UNITED STATES PATENT AND TRADEMARK OFFICE

APPLICATION NO.	FILING DATE	FIRST NAMED INVENTOR	ATTORNEY DOCKET NO.	CONFIRMATION N
10/803,419	03/18/2004	Daniel D. Friel SR.	FRIEL-105	5873
7590	10/19/2004		EXAMINER	
Connolly Bove Lodge & Hutz LLP			SHAKERI, HADI	
P.O. Box 2207			ART UNIT	PAPER NUMBER
Wilmington, DE 19899-2207			3723

Office Action Summary	Application No. 10/803,419	Applicant(s) FRIEL ET AL.	
	Examiner Hadi Shakeri	Art Unit 3723

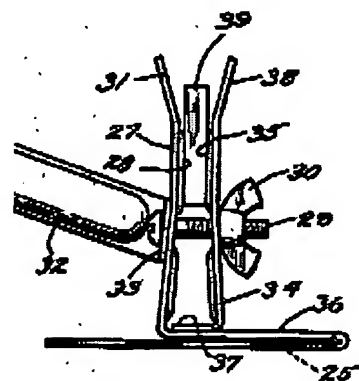
14. Claims 1, 2, 13, 44, 46 and 53 (as best understood) are rejected under 35 U.S.C. 102(b) as being anticipated by Brinkley (2,559,273).

Brinkley discloses all of the limitations of claims 1, 13, 44, and 53, i.e., a knife conditioner, comprising a guide (31, 38) and an object having hardened surface (39) and a method for conditioning using the apparatus. Note that lacking any structures to distinguish between "sharpening" and "conditioning" the prior art as cited is considered to meet the recitation.

Regarding claims 2, 46 and 50, Brinkley meets the limitations, e.g., handle (32); support member (27, 25, 36) and guide (38) pivotally mounted to the support at (34, 37), and adjusting structure (29, 30).

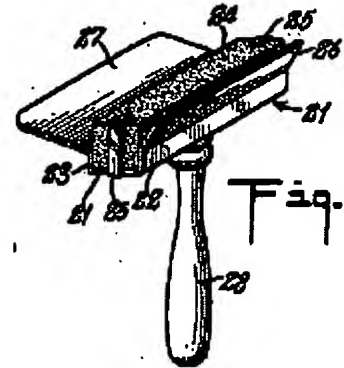
15. Claims 1, 2, 13, 44, 46 and 53 (as best understood) are rejected under 35 U.S.C. 102(b) as being anticipated by Andrews (2,645,066).

Andrews discloses all of the limitations of claims 1, 13, 44, and 53, i.e., a knife conditioner, comprising a guide (26) and an object having hardened surface (24) and a method for conditioning using the apparatus. Note that lacking any structures to distinguish between "sharpening" and "conditioning" the prior art as cited is considered to meet the recitation.

Regarding claims 2, and 46, Andrews meets the limitations, e.g., handle (28).
